Addendum No.: 2

York Correctional Institution Central Plant and Piping Distribution

BI – JA – 465

The following clarifications are applicable to drawings and specifications for the project referenced above.

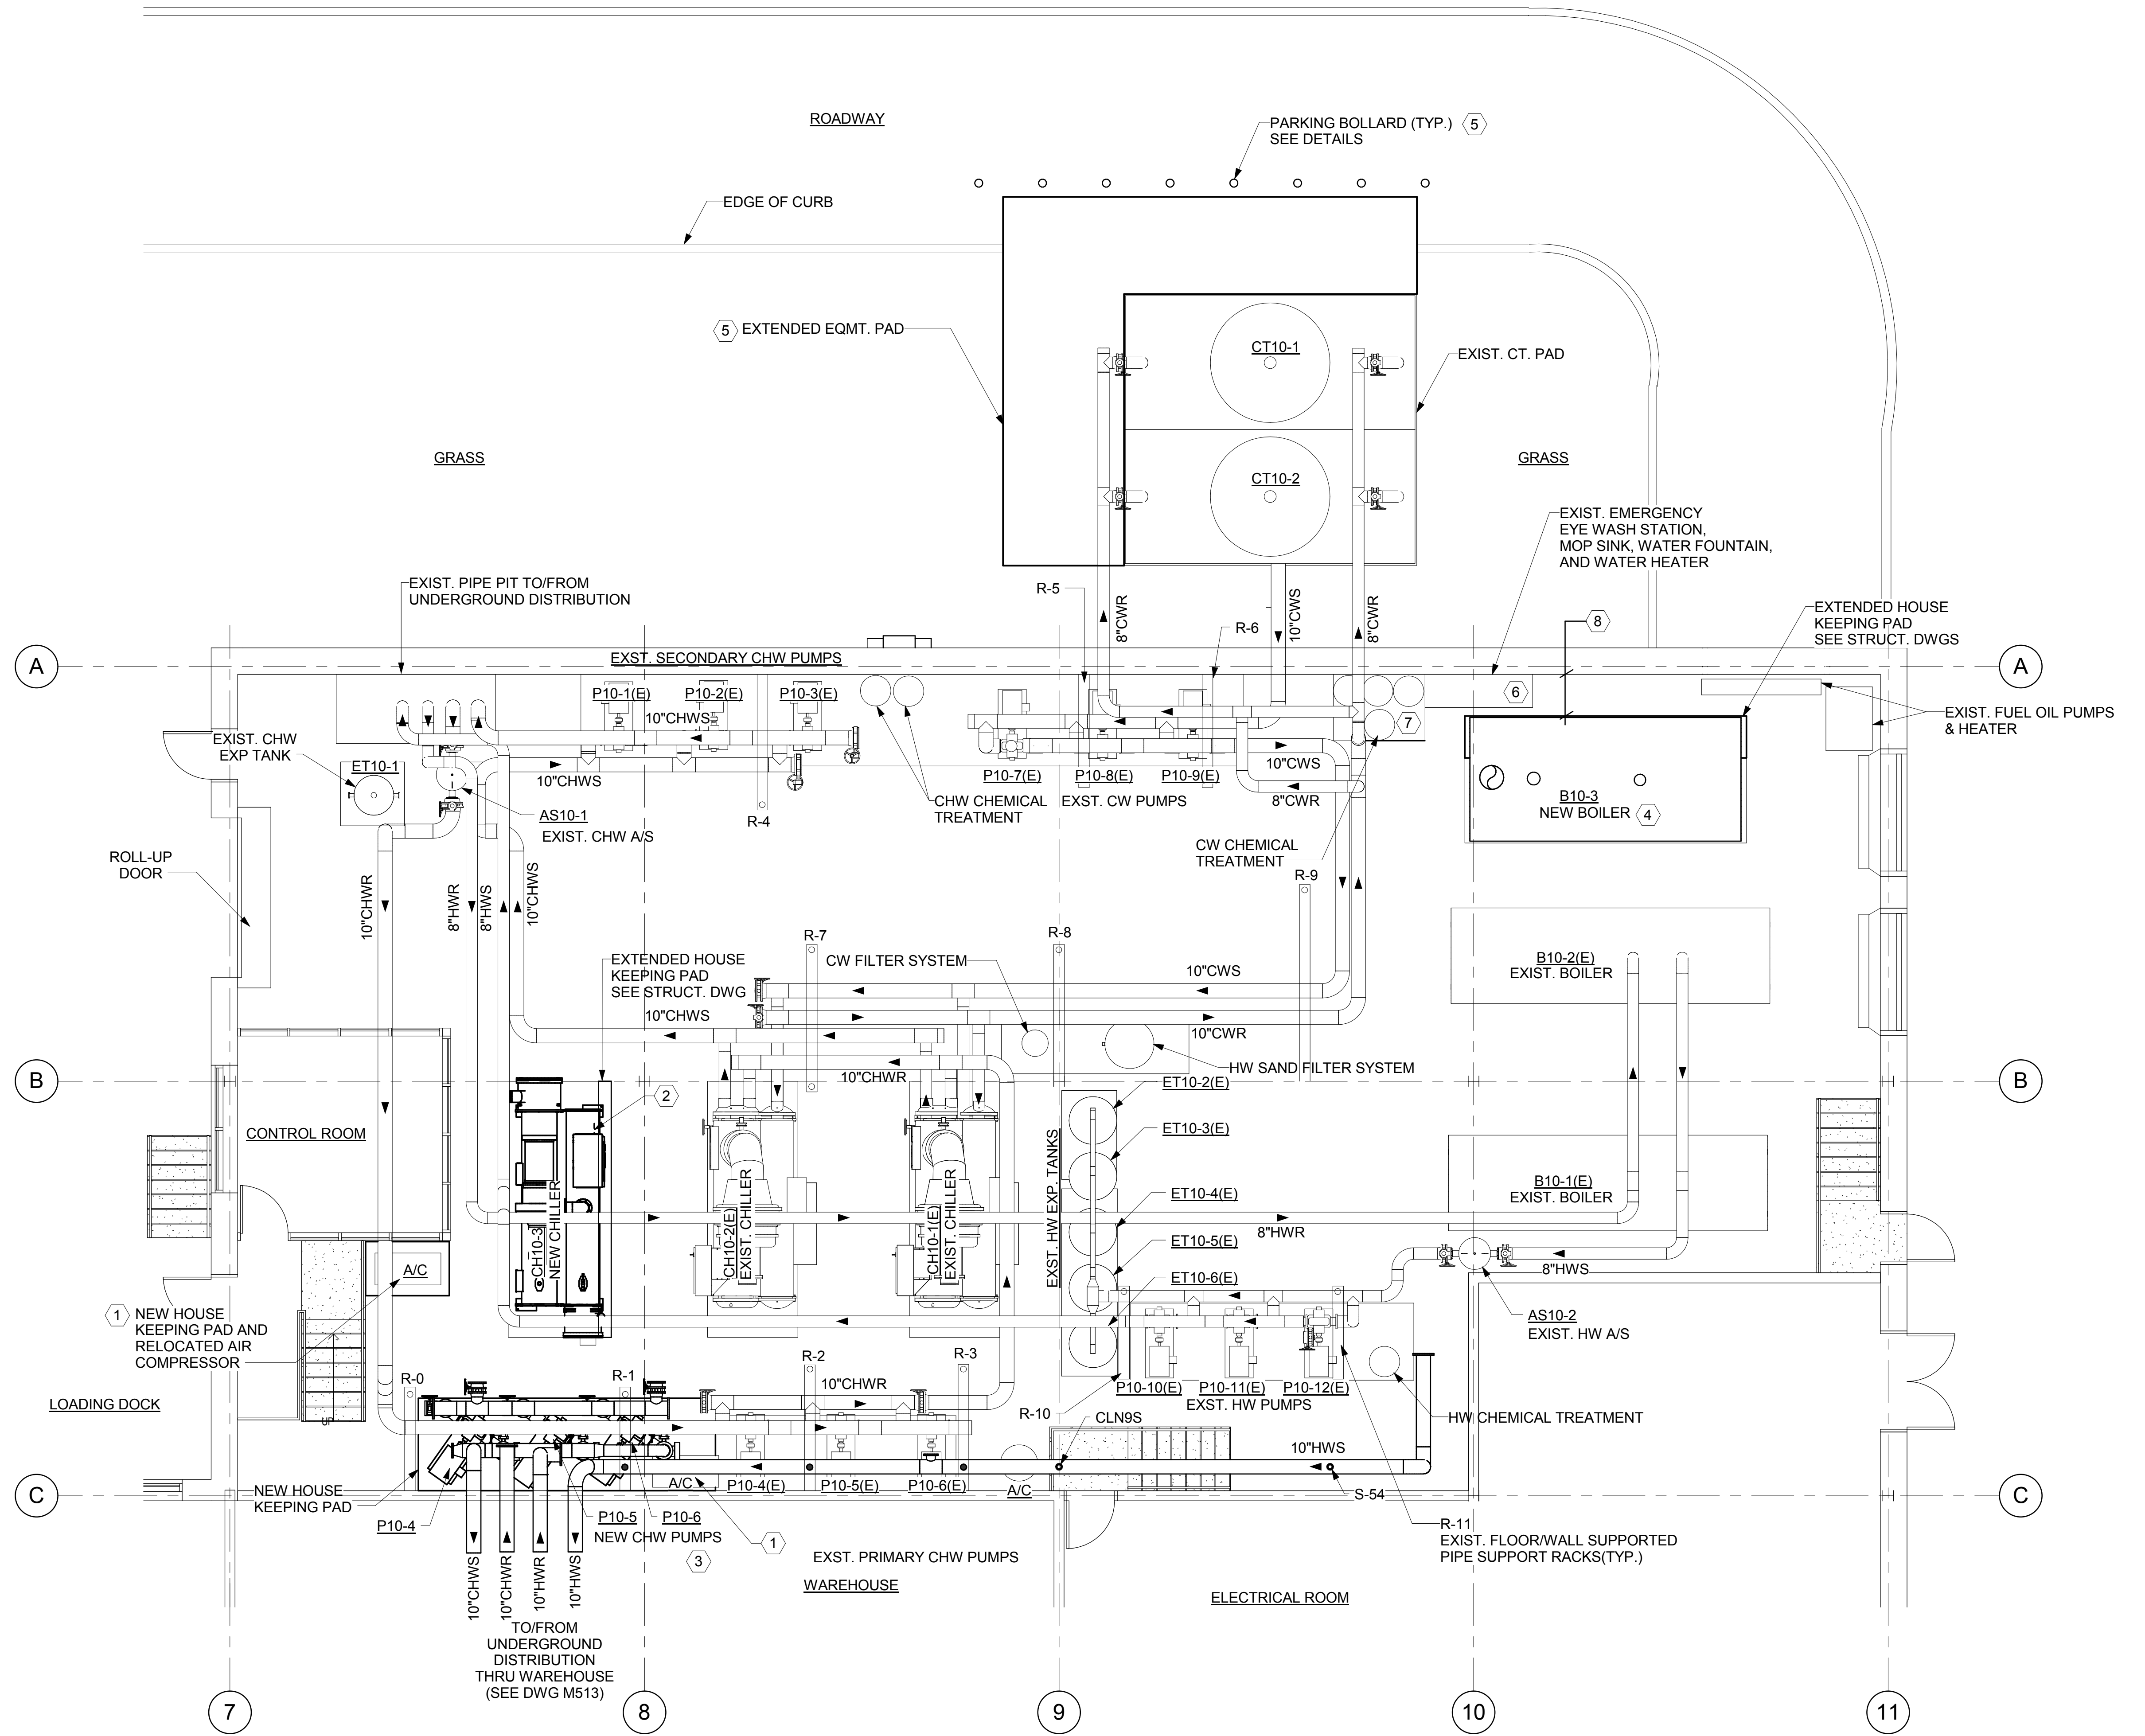
Drawing M501 Central Plant Plan Installation Phase 1

**REPLACE** the entire drawing with the attached.

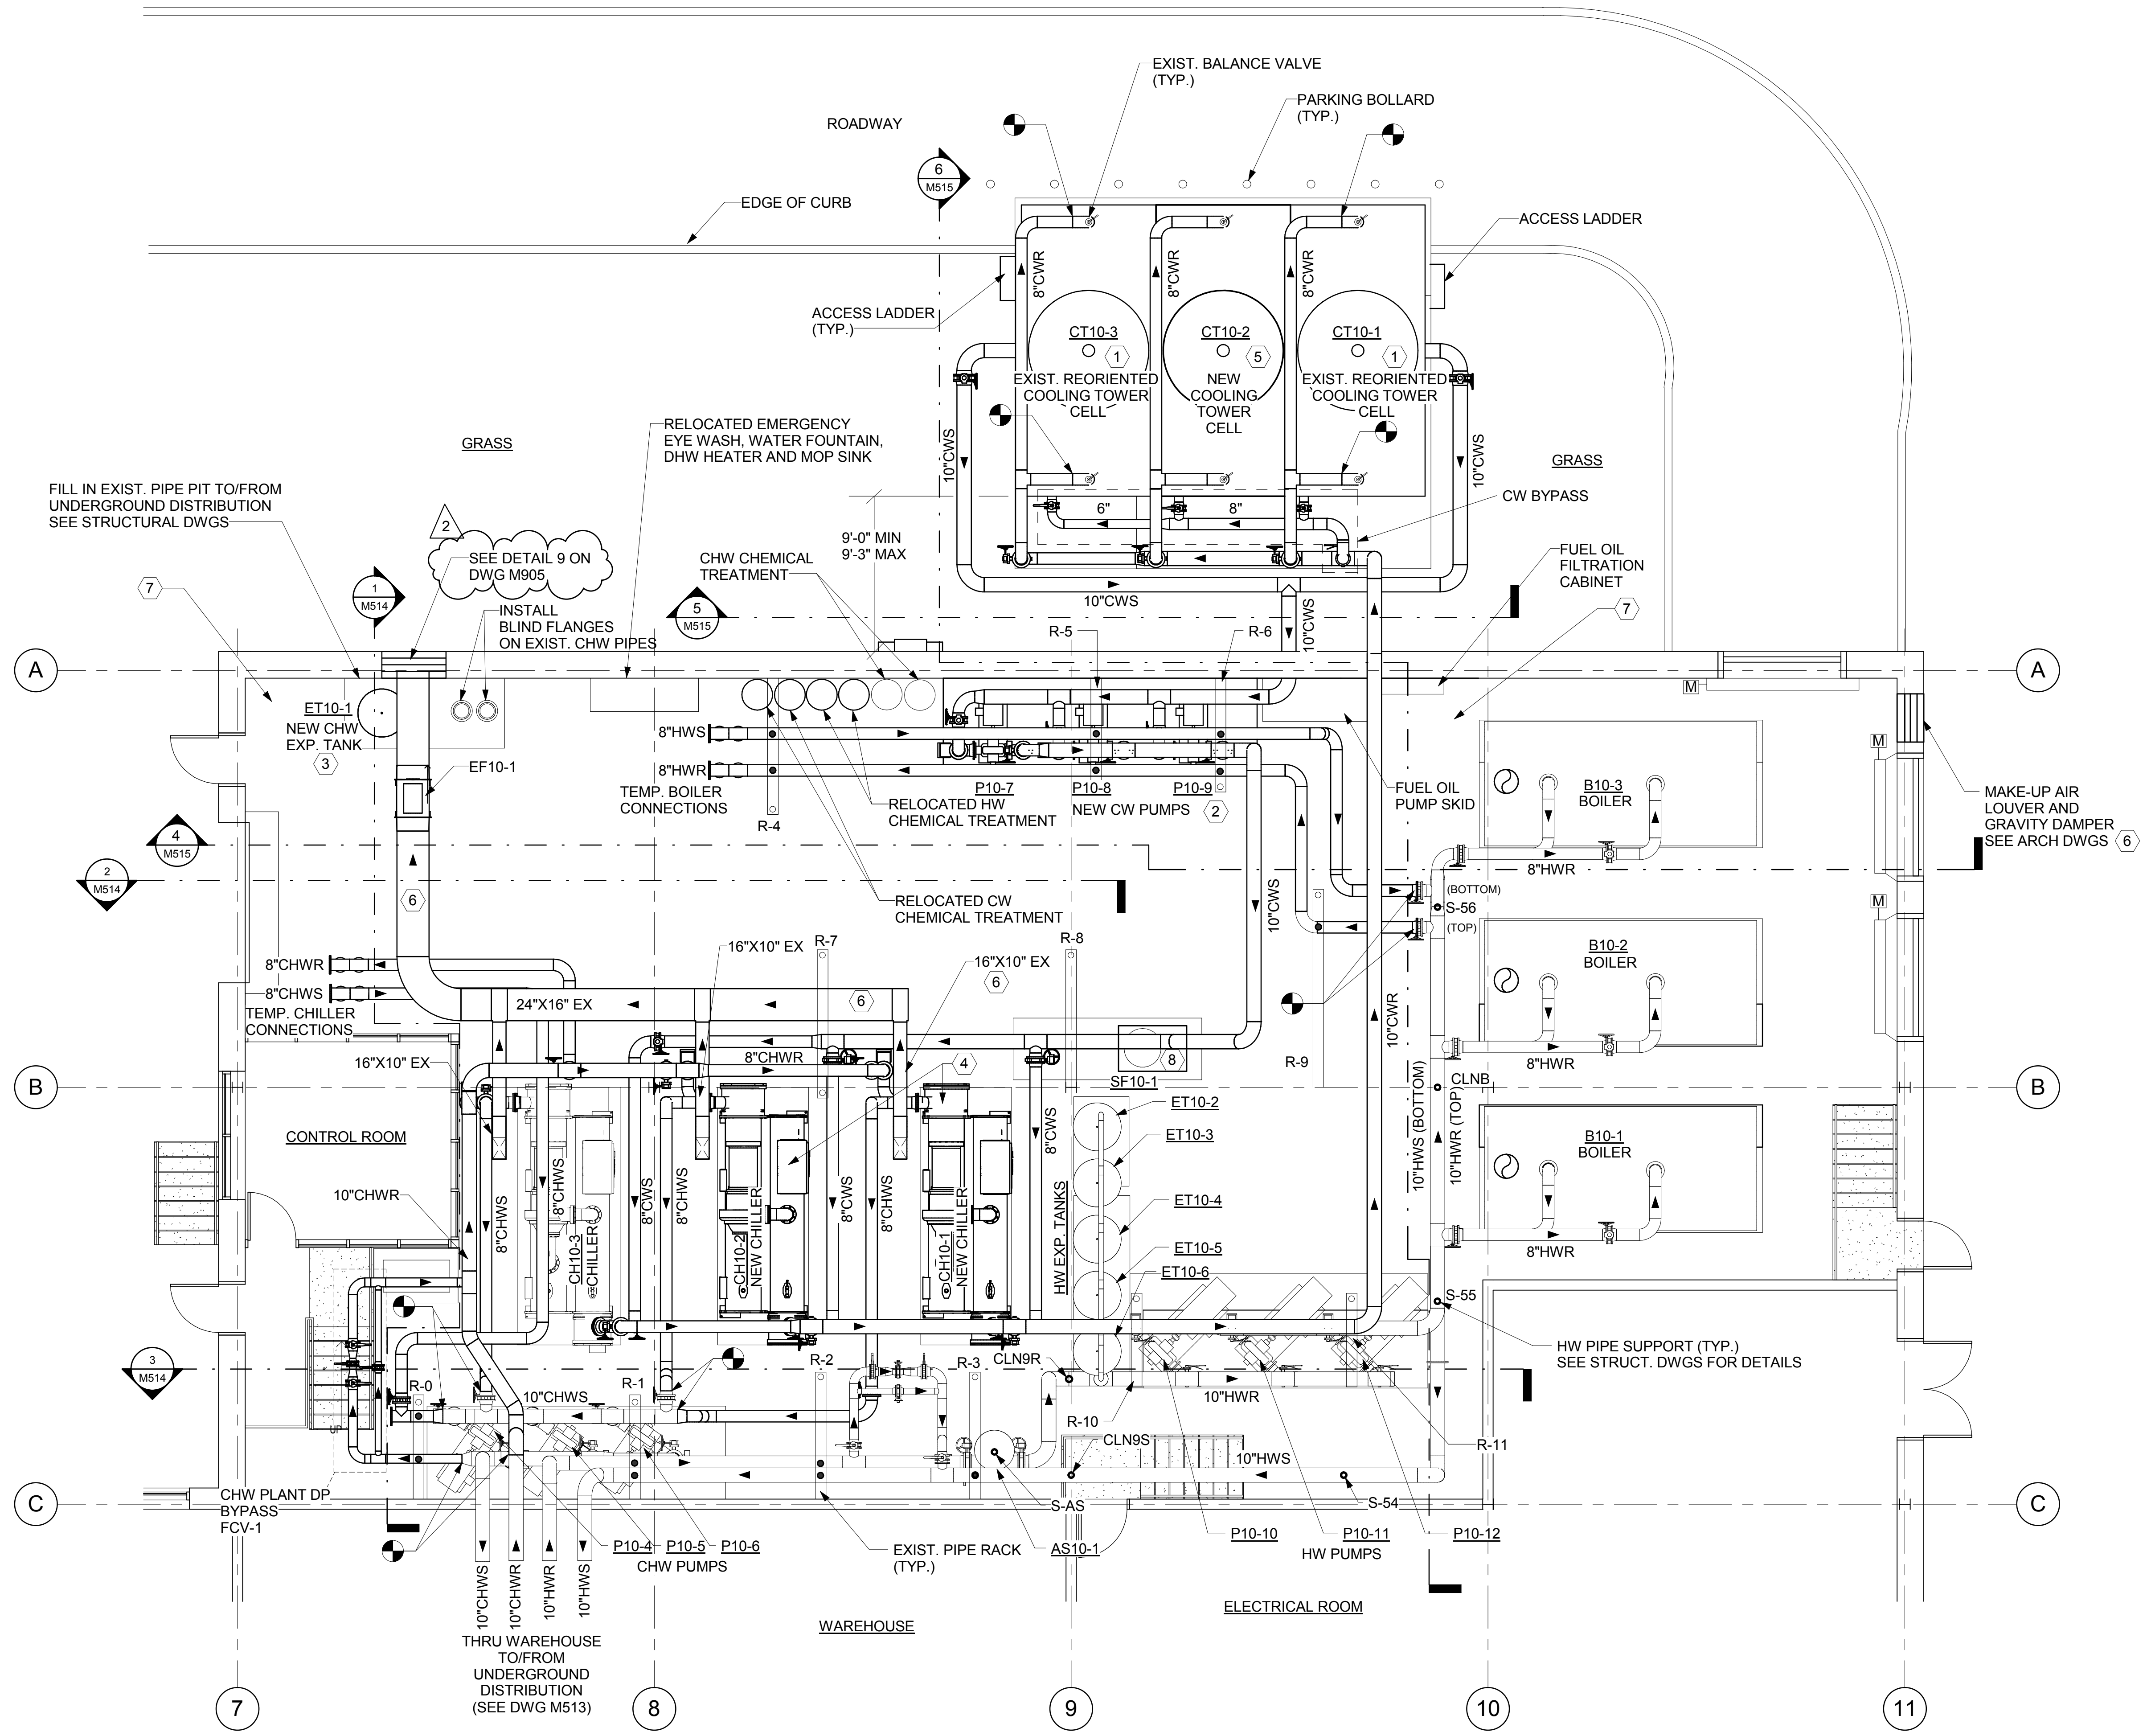
Drawing M505 Central Plant Plan Installation Phase 5

**REPLACE** the entire drawing with the attached.
